Report #: 2510-5288

Review and Discussion of Foothills Nature Preserve Improvements Project Scope Reduction

FOOTHILLS NATURE PRESERVE IMPROVEMENTS PROJECT REDUCED SCOPE EXHIBIT

FOOTHILLS NATURE PRESERVE IMPROVEMENTS

Attachment A: Foothills Nature Preserve Improvements Project Reduced Scope Exhibit.

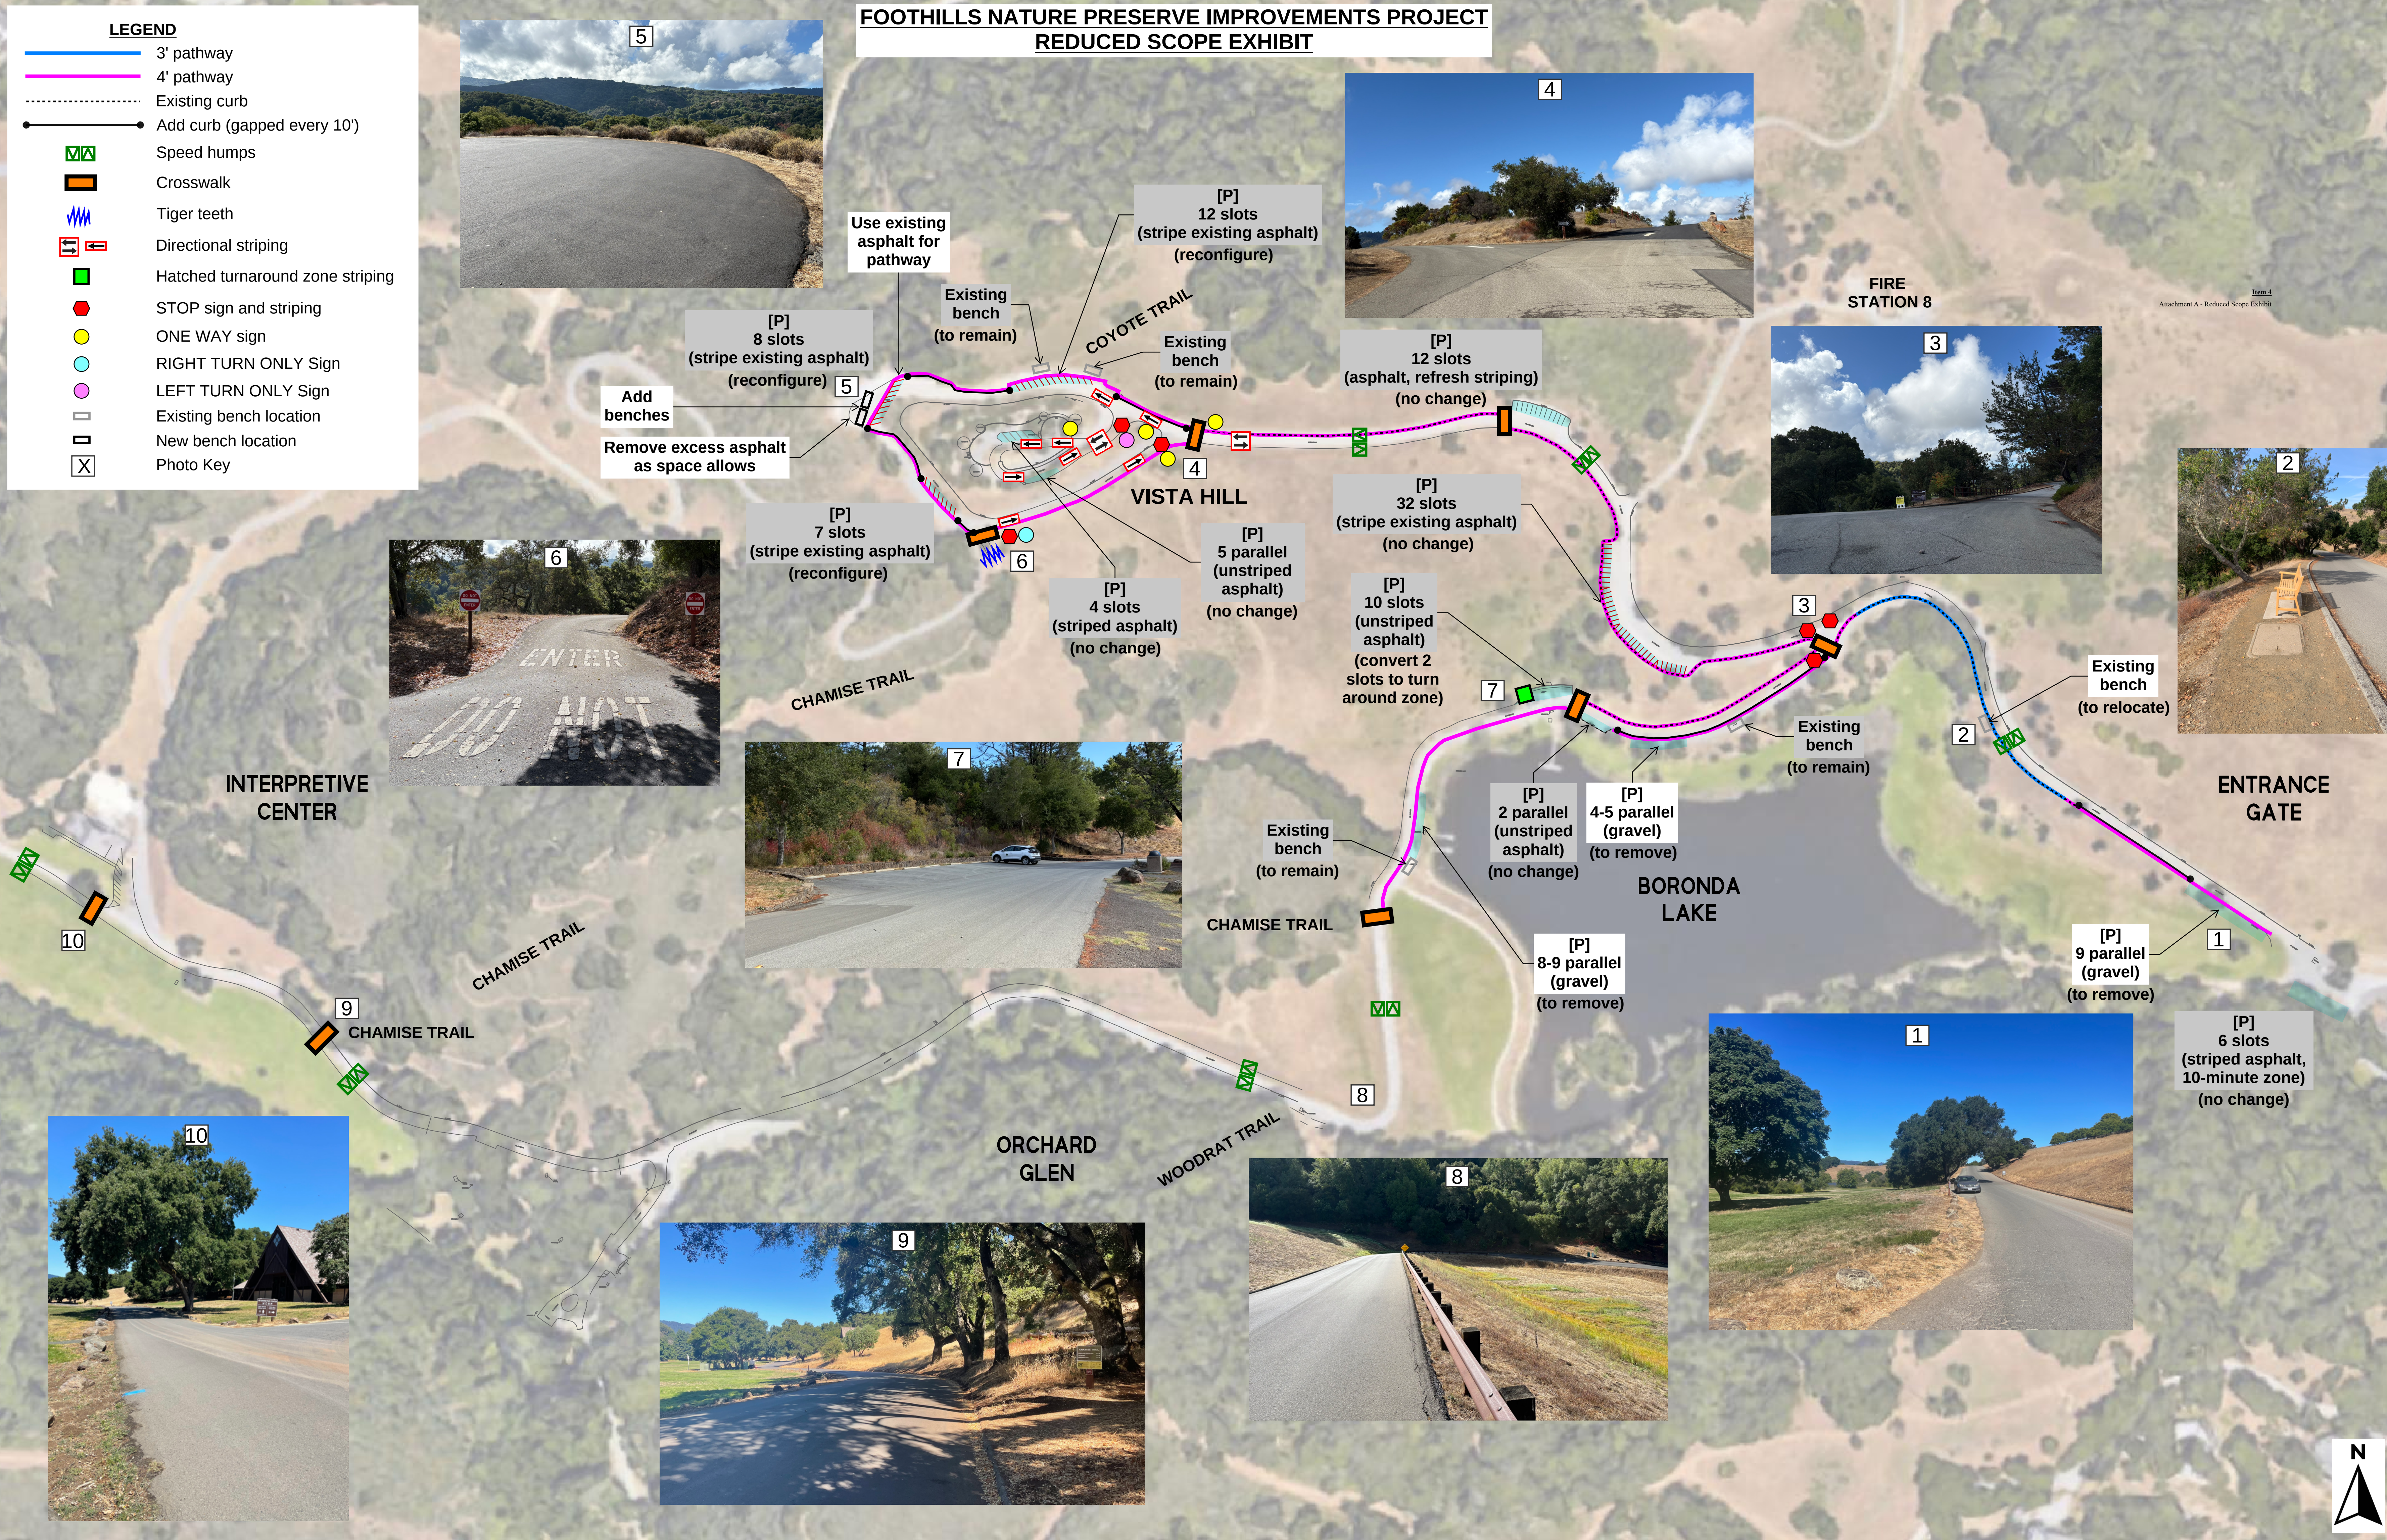
- c. Per PRC Open Space liaisons input and upon revisiting parking in each of the improvement areas, staff has removed the new parking lot across from Boronda Lake. The visitors will be able to use the overflow parking lot when needed and may walk to the lake via the new pathway through the Y-connection.

- d. Reconfiguration of the existing asphalt parking on the western side of Vista Hill, and renaturalize by removing asphalt that is not necessary.

1. The original plan included up to 6 feet wide new pedestrian pathways along preserve roads from entrance to Interpretive Center and from Boronda Lake to Vista Hill. The proposed plan has been revised by reducing pathway widths to 3 to 4 feet and eliminating new pathways from Boronda Lake to Interpretive Center.

2. The existing boulders will be utilized where feasible instead of curb along the entire stretch of pathways. Only the areas where existing boulders are not available or feasible will have asphalt curb.

3. The new trail connecting the Boronda Lake overflow parking to the lake through sensitive area has been removed to eliminate impacts on sensitive habitats.

4. New asphalt parking across Boronda Lake has been eliminated.
5. Bus parking at Vista Hill has been removed.
6. Bike racks were installed by staff at Boronda Lake, Orchard Glen and Interpretive Center. Additional bike racks will be installed in spring 2026.

1. Pedestrian pathways:

- a. New designated pedestrian pathways along preserve roads connecting entrance, Boronda Lake and Vista Hill. Pathways will be about three to four feet wide and constructed of quarry fines material. Quarry fines is a mixture of fine sand, silt and clay-like material generated as a by-product of quarrying operation. This material has been used at Arastradero Preserve for similar purposes and has performed well. Existing asphalt would be used for pathways at Vista Hill as feasible.

- b. Existing boulders will be utilized as a safety barrier between pedestrians and vehicular traffic where feasible.
- c. New asphalt curb will be added along the edge of the pedestrian pathways as safety barrier where necessary with curb cuts to allow for stormwater flows and wildlife crossing. The curb will also ensure vehicles do not park on pedestrian pathways.

2. Parking improvements:

- a. Reconfigure existing parking spaces around Vista Hill and Boronda Lake to provide safer and efficient access for vehicles. Some parallel parking spaces will be removed along Boronda Lake and entrance road to accommodate new pathways and provide more consistency with parking patterns in the preserve by prioritizing head-in parking.

- b. No new parking lots will be constructed. The project proposes refreshing the existing parking lots as shown in Attachment A with striping to clearly delineate parking stalls. This will maintain natural appearance and enhance visitors' experience.

ORIGINAL DRAFT IMPROVEMENT PLAN (2023)

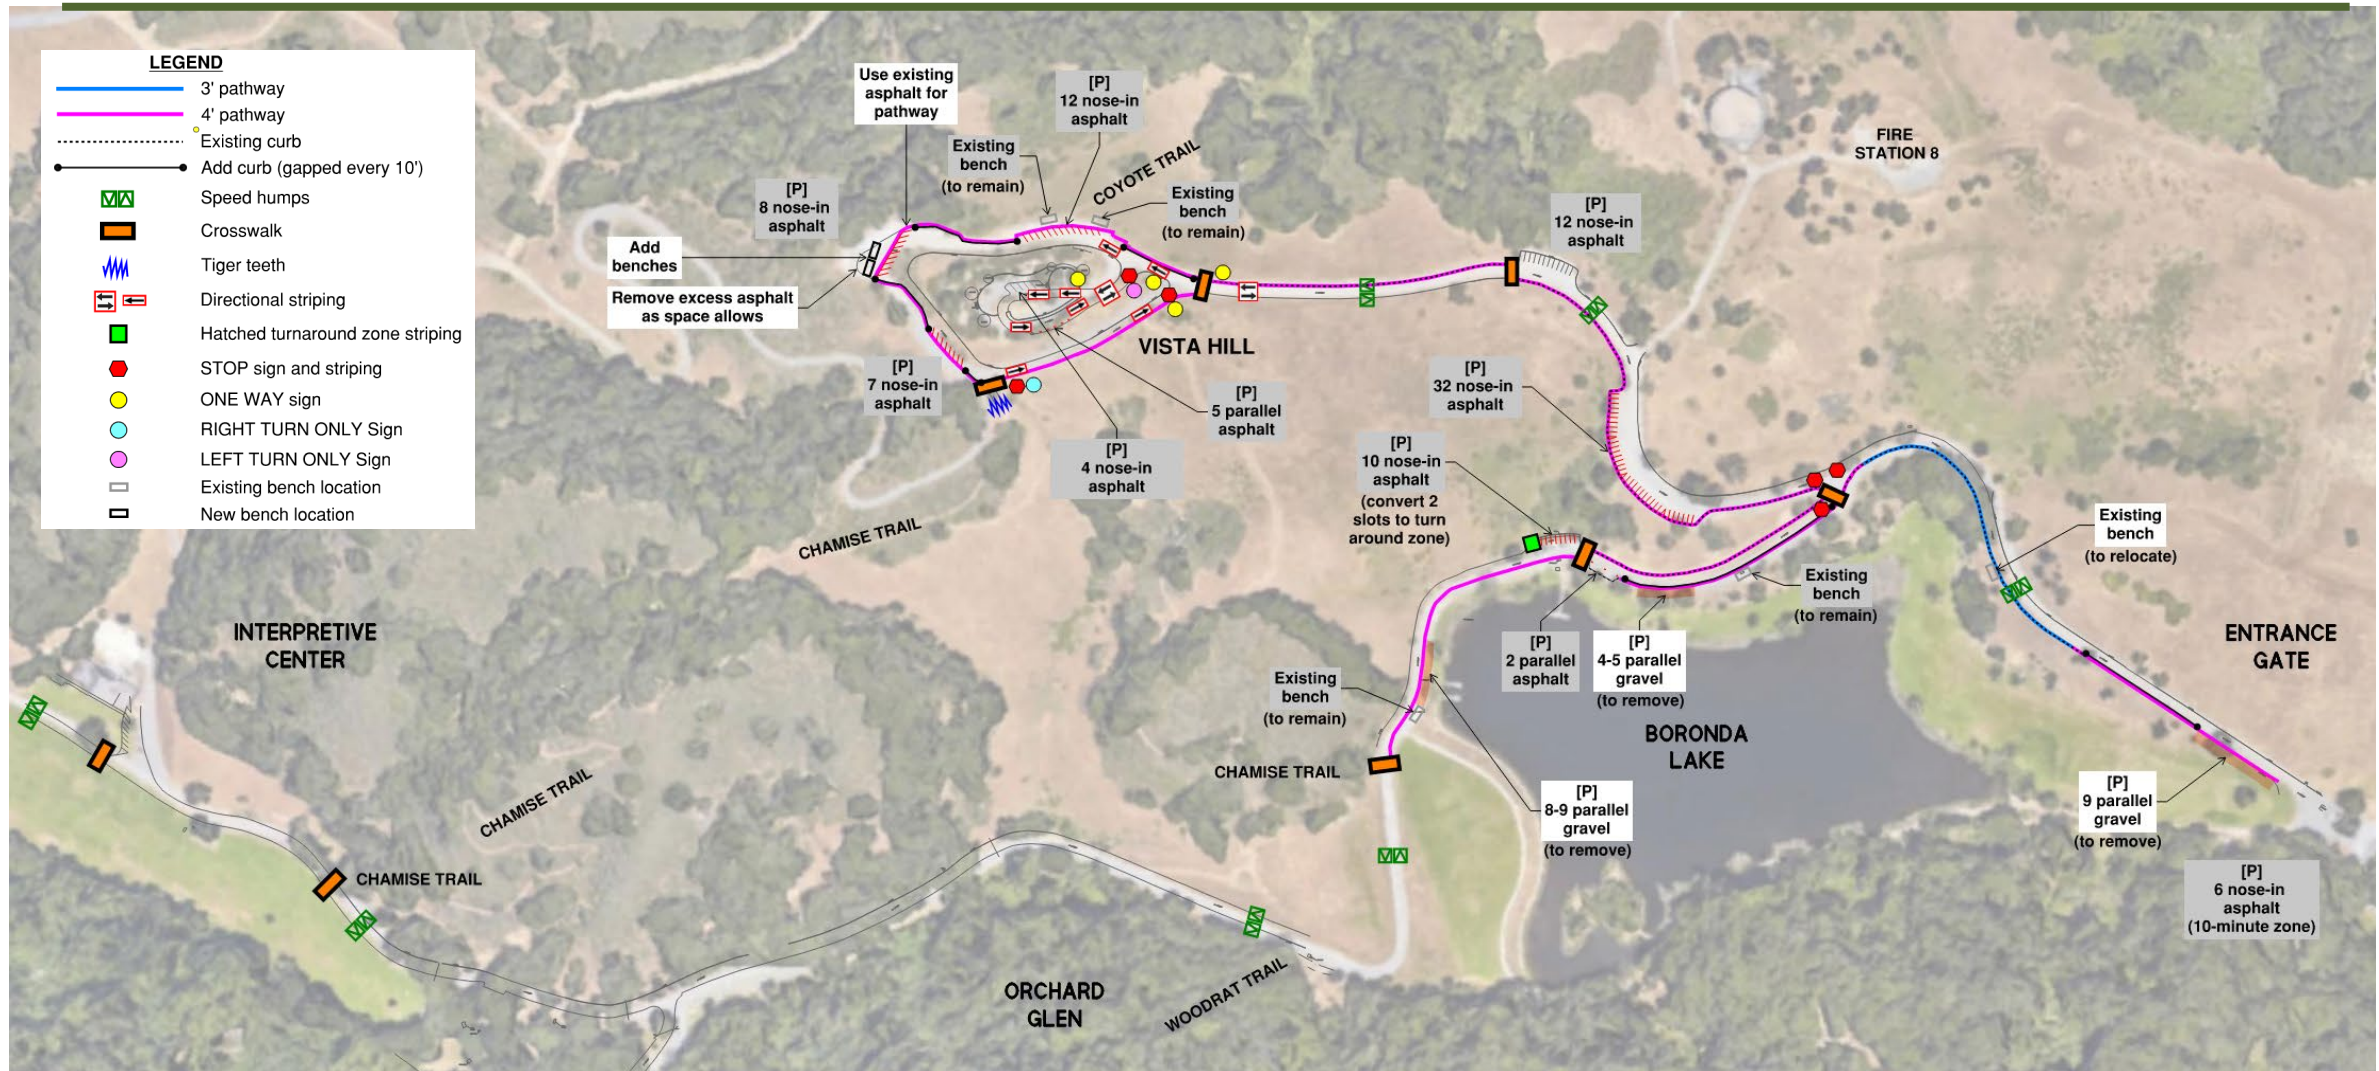
- Pedestrian pathway width reduced from 6 feet to 3 and 4 feet.
- Existing boulders to be used as safety barriers. Asphalt curb to be installed only in areas where boulders are not feasible.

- Pedestrian pathway from Boronda Lake dam to Interpretive Center.
- Trail connecting overflow parking to Boronda Lake through sensitive habitat.
- Bus parking at Vista Hill.
- New asphalt parking lot across Boronda Lake.
- Addressed by staff: Bike racks at Boronda Lake, Orchard Glen and Interpretive Center; split rail fence
